Applicant: SkyWater Technology Foundry, Inc.

Location: 2401 and 2411 East 86th Street

Request: 1) Rezone from CO-1(PD) (AR-17) to IT (PD) (AR-17)
2) Major Revision to Preliminary Development Plan and Final Development Plan for an Expansion

Proposed Zoning

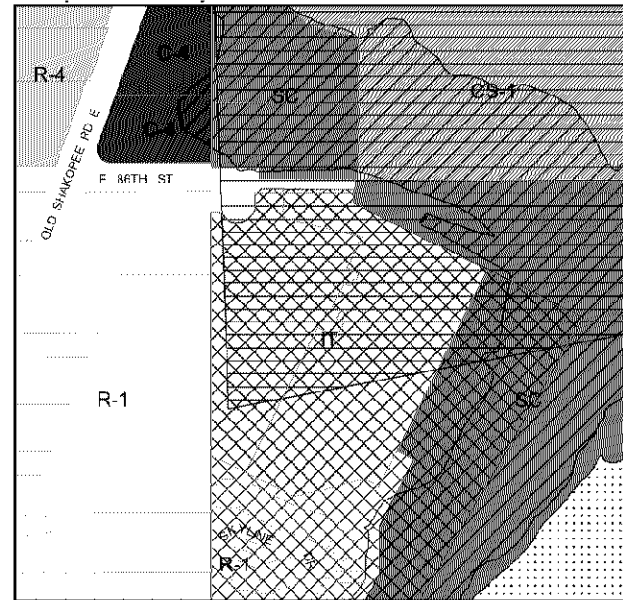
Staff believes the proposed base zone change and preserving the planned development overlay, as depicted in Graphic 1 below, is consistent with the Comprehensive Plan and provides a public benefit by implementing the Comprehensive Plan and South Loop District Plan. As part of the 2019 Planning Commission work plan, the City intended to initiate rezoning of this parcel, along with others, to IT.
